MEMORANDUM

RE: Ross Complex Subdivision (Case #: C8-2013-0221.0A)

Figure 1. Google photograph of the Spiers Way stub street looking into the proposed subdivision and toward the Del Valle Elementary School.

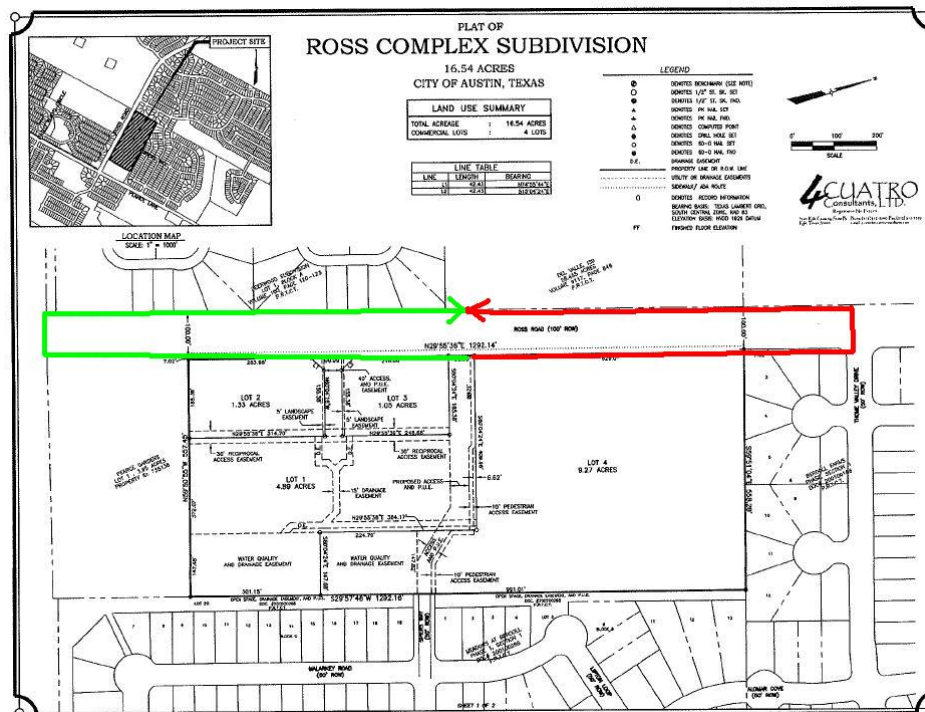
1. Connecting Spiers Way to Ross Road provides for a pedestrian connection as required by current Subdivision Regulations. Figure 1 below shows the existing stub street.
